File Number: CC-27-83  
Date Received: 9/28/83  
3-Month Period Ends: 12/25/83  
6-Month Period Ends: 3/25/84  
Staff: LIT. & Staff.  
Hearing Date/Item: 2/23/84 - 4b.

REGULAR CALENDAR  
PRELIMINARY STAFF RECOMMENDATION ON CONSISTENCY CERTIFICATION

Applicant for Federal Permit: Texaco USA, Inc.  
Project Location: On offshore lease tract OCS P-0315, approximately 11 miles west of Point Conception, Santa Barbara County (see Exhibit 1)  
Project Description: One 50 well slot drilling and production platform; two subsea oil and gas pipeline from Texaco's Platform Harvest to Chevron's Platform Hermosa. The hydrocarbons will be transported through Chevron's consolidated pipeline to onshore consolidated processing facilities.

**FIGURE 5-1**  
**SOLID MUD**  
**COMPONENT DILUTION**  
**vs DISTANCE FROM**  
**DISCHARGE POINT**

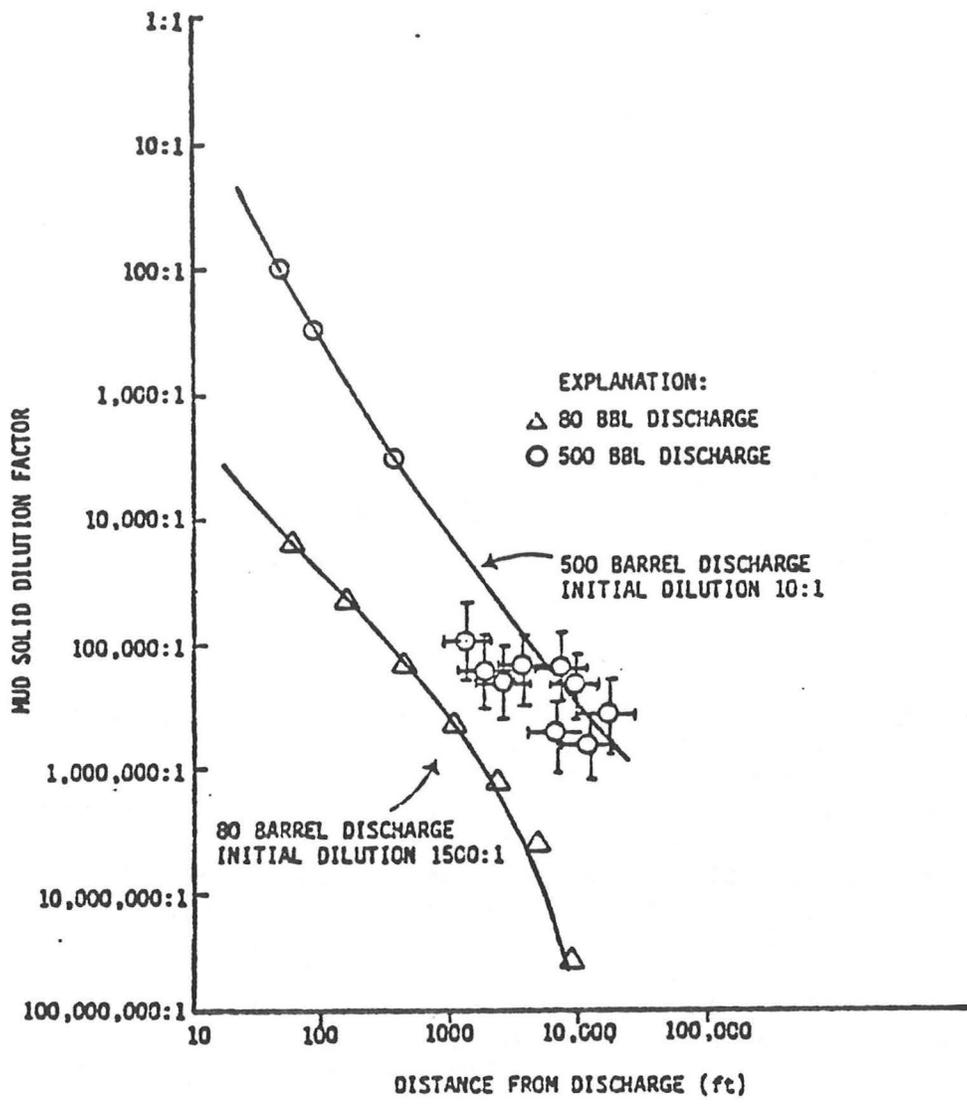
The OOC model was run with a total of six simulations. Three simulations used a typical discharge rate of 80 barrels per day along with oceanographic conditions found to occur most frequently during three current regimes which exist west of Point Conception. Three additional simulations were performed using the same current inputs, but assuming a high volume discharge in a short time period (500 barrels in one hour).

Exhibit 3 plots the mud solid dilution factor as a function of distance from discharge for both the typical and high volume discharges. The results show that the dilution of discharged muds occurs very rapidly. For example, under the Oceanic Current, a typical discharge would be diluted by approximately 450,000:1 within 3.6 hours at a distance from the discharge point of 1,293 feet. This is equivalent to a concentration of approximately .675 ppm. The 96-hour LC<sub>50</sub> value for exposure to a whole fluid, in the most sensitive species, is 100 ppm.

**PROPOSED TRAFFIC  
SEPARATION SCHEME  
WESTERN SANTA BARBARA  
CHANNEL**

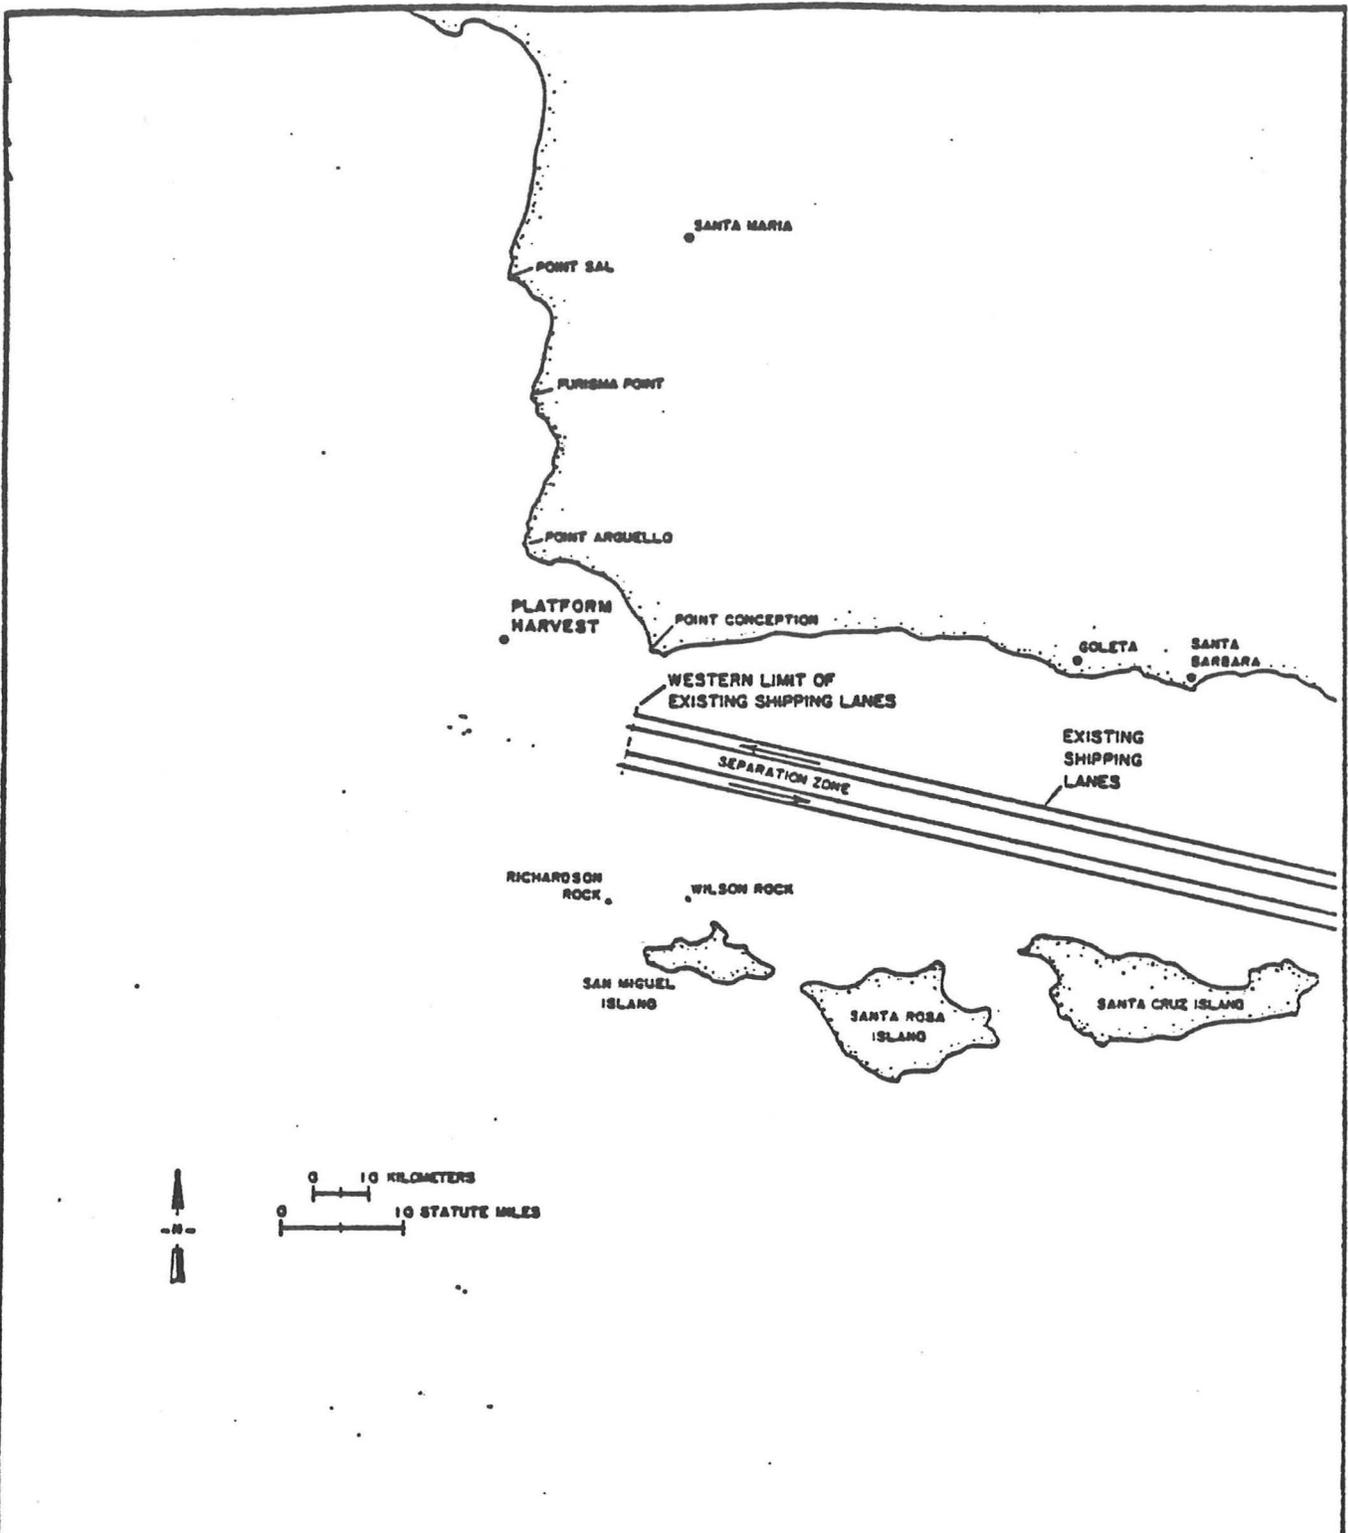
Platform Site. Texaco proposes to site Platform Harvest approximately eleven miles northwest of the Santa Barbara Channel Vessel Traffic Separation Scheme (VTSS) (see Exhibit 7). Although there are no platforms currently in the area, four platforms, including Harvest, are planned for the area. Chevron's Hermosa, proposed to be located approximately 11,000 feet (approximately two miles) east of Harvest, has already been certified by the Commission.

Presently, vessels traveling through the Santa Barbara Channel that have a destination on the North American coast commonly turn north after passing Point Conception, near the end of the existing Santa Barbara Channel VTSS. They then pass through the general area of the proposed platform site. Coast Guard radar tracking confirms this route, as does information contained in the State Lands Lease Sale EIR.

The U.S. Coast Guard request for a northwesterly extension of the present Santa Barbara Channel Vessel Traffic Separation Scheme has been rejected by the International Maritime Organization (IMO), and, therefore, vessels will, in large part, continue to pass through the proposed area of Harvest. Such a potentially congested situation requires more than the Coast Guard minimum requirements for aids to navigation.
